NON-CONFIDENTIAL

| 1 | Requ | est IR-1: |
| 3 | REFI | ERENCE: M-2 (APPLICATION), P. 18-19 |

Figure 4-4 Weighted Average Electricity Prices Per MWh

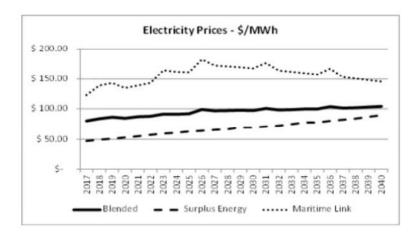
(a) Please provide, in a Microsoft Excel worksheet, the data used to produce Figure 4-4.

(b) Please specify, in a Microsoft Excel worksheet, for each year from 2017 to 2040, the respective quantities of Maritime Link energy and of « surplus » energy used to calculate the "Blended" price indicated in Figure 4-4.

(c) Please provide, in a Microsoft Excel worksheet, the detailed calculations used to define the annual price of Maritime Link energy in Figure 4-4.

(d) Please provide a detailed narrative explanation of the approach used to estimate the price of purchased Surplus Energy in Figure 4-4.

| 1 | (e) | Please provide, in a Microsoft Excel worksheet, the detailed calculations used to |
| 4 | (f) | Please indicate whether Figure 4-4 represents real or nominal dollars. |
| 6 | (g) | Please indicate if the Surplus Energy prices used in preparing Figure 4-4 |
| 9 | (h) | Please provide alternate versions of Figure 4-4, along with (in Excel format) the |

Figure 4.1 Estimated Range of Capital Investments to Support Large Scale Wind
Integration

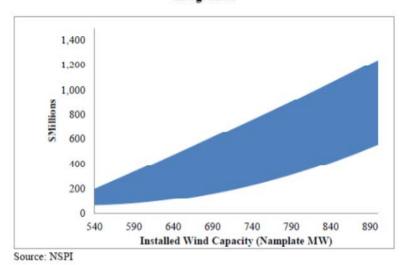
3 REFERENCE: M2(vi), App. 6.02, Figure 4.1, p. 38
